Appl. No. 10/659,933  
Amdt. Dated February 28, 2006  
Reply to Office Action of November 30, 2005

Attorney Docket No. 81863.0021  
Customer No.: 26021

**Amendments to the Drawings:**

The present invention relates to a throw-away style cutting tip used for cutting a cast iron and a steel. (Applicant's specification, at p. 1, lines 5-6).

FIG.3

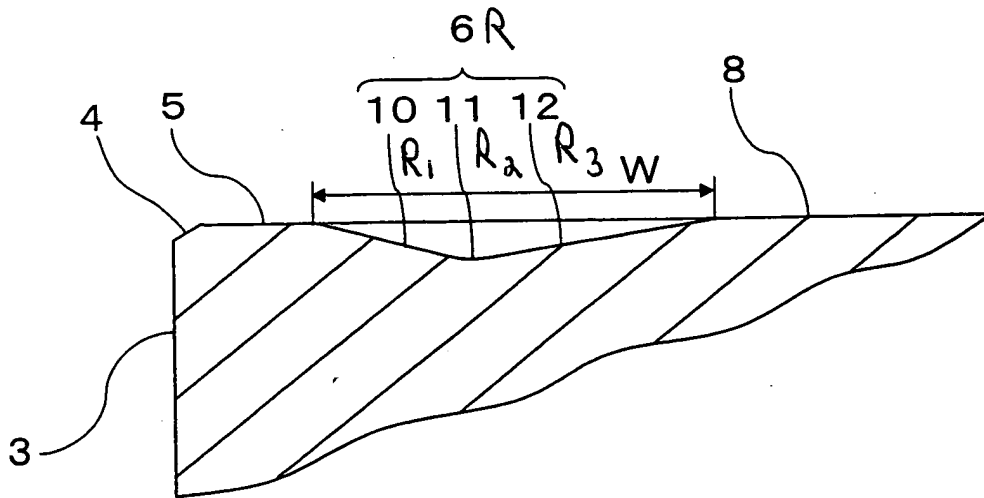
The attached sheets of drawings include changes to Figure 3.

The drawings are objected to under 37 C.F.R. 1.83(a) because they fail to show R, R1, R2 and R3 as described in the specification at p. 9, line 23-p. 10, line 15 and this structural detail is essential for a proper understanding of the disclosed invention. The Applicant respectfully disagrees.

The Office states that the disclosure is objected to because of the references R, R1, R2 and R3. As discussed above, Figure 3 was amended to include the references R, R1, R2 and R3. Withdrawal of this objection is thus respectfully requested.

The Applicant respectfully submits that the specification at p. 9, line 23-p. 10, line 15 lists reference numerals together with R, R1, R2 and R3 and this information allows for a proper understanding of the disclosed invention. However, in order to expedite the prosecution of the instant application, the Applicant added the references R, R1, R2 and R3 to Figure 3. Withdrawal of this objection is thus respectfully requested.
